Docket No. 50-263

NORTHERN STATES POWER COMPANY  
DOCKET NO. 50-263  
MONTICELLO NUCLEAR GENERATING PLANT  
AMENDMENT TO PROVISIONAL OPERATING LICENSE

Amendment No. 33  
License No. DPR-22

ATTACHMENT TO LICENSE AMENDMENT NO. 33

FIGURE 6.1.2

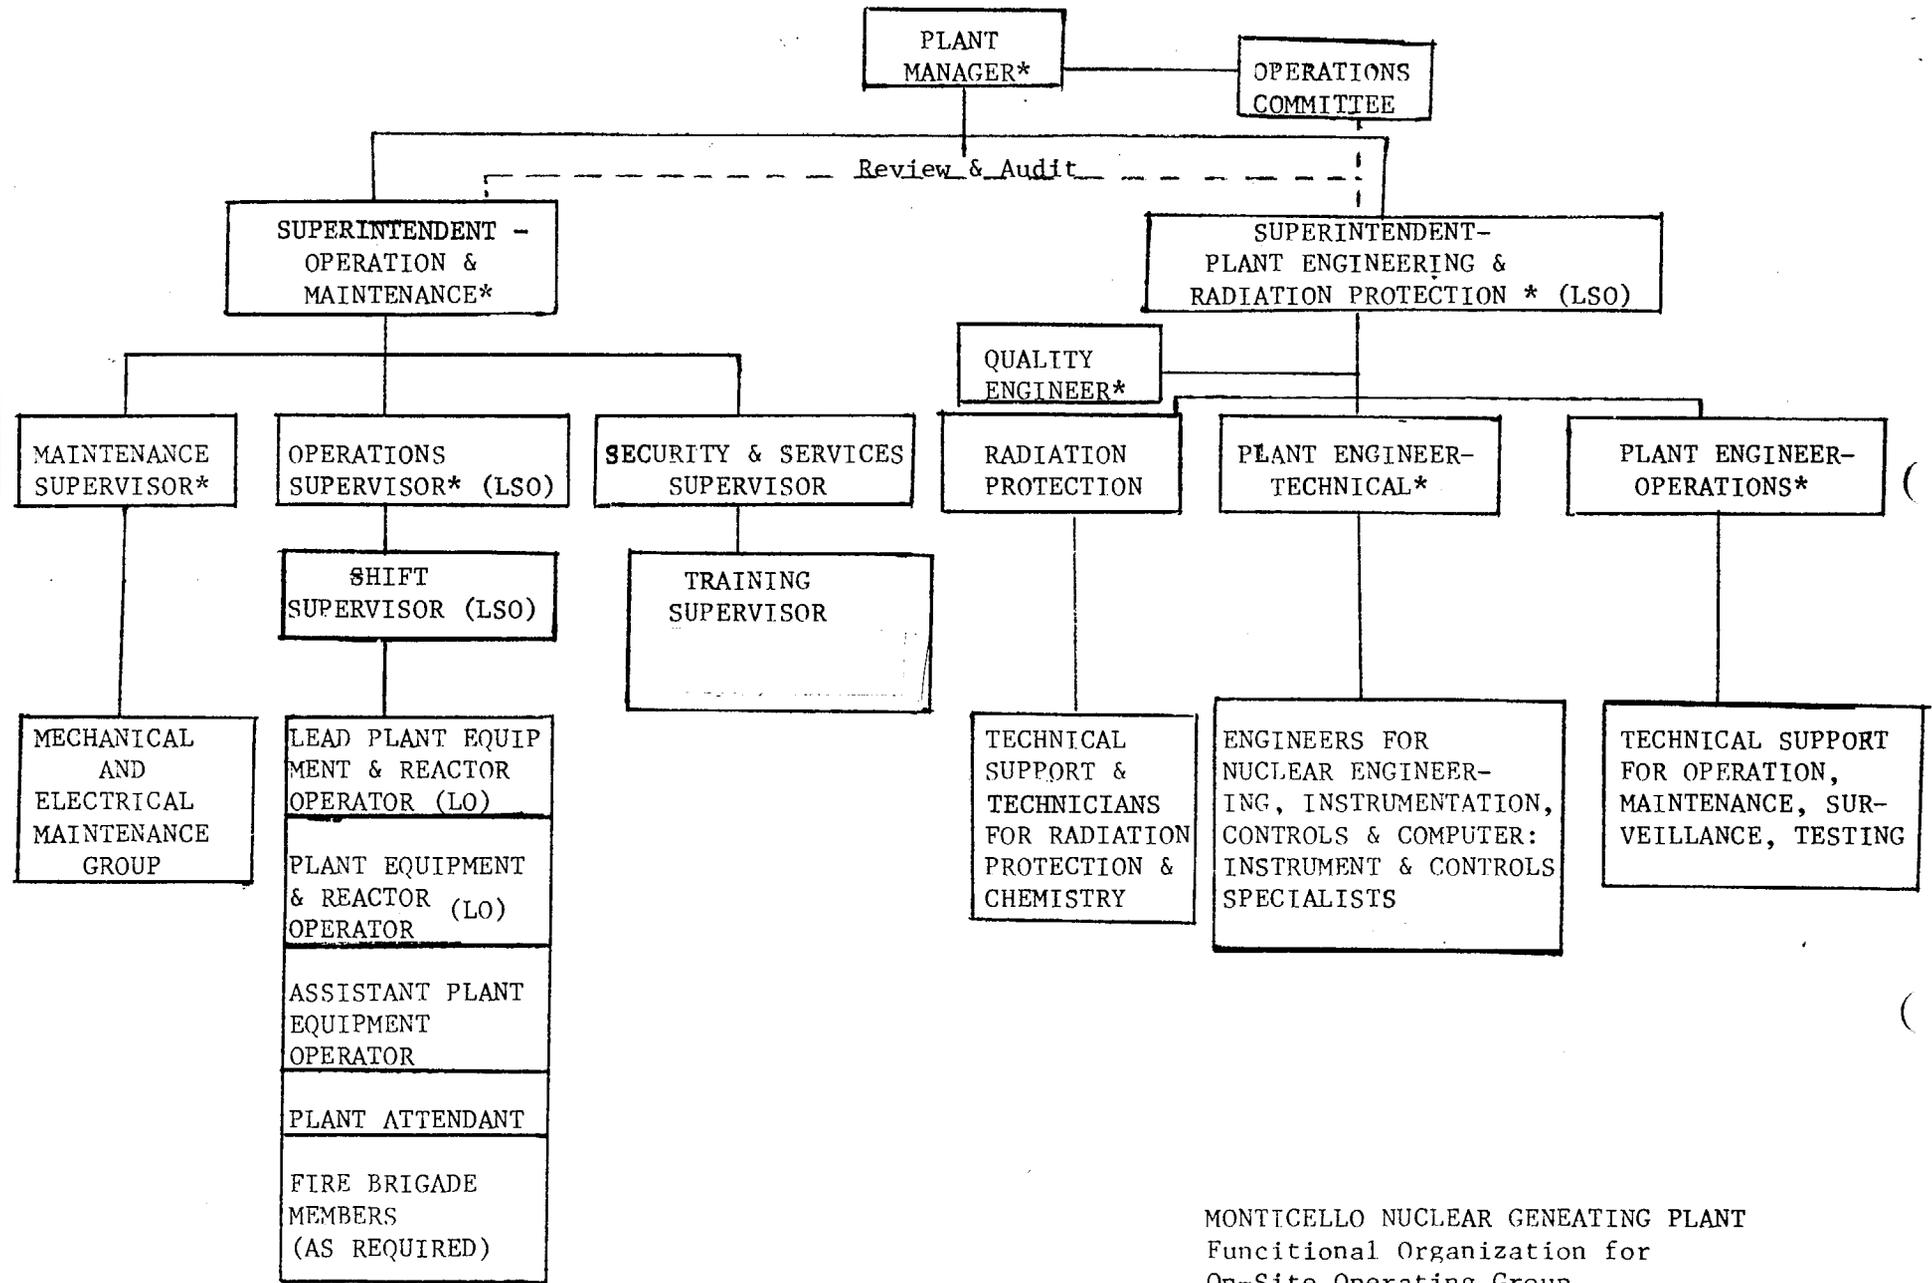
The same consideration is being given to Specification 4.13.B.1.k (concerning valve position verification) and Figure 6.1.2. (concerning specification of responsible fire protection personnel). Specification 4.13.B.1.k and Figure 6.1.2 have been issued as requested in your December 16, 1977 letter. However, upon completion of our further review, we may require that the specification and figure be modified.

- B. The Northern States Power corporate organizational structure relating to the operation of this plant is shown in Figure 6.1.1.
- C. The minimum functional organization for operation of the plant shall be as shown in Figure 6.1.2 and:
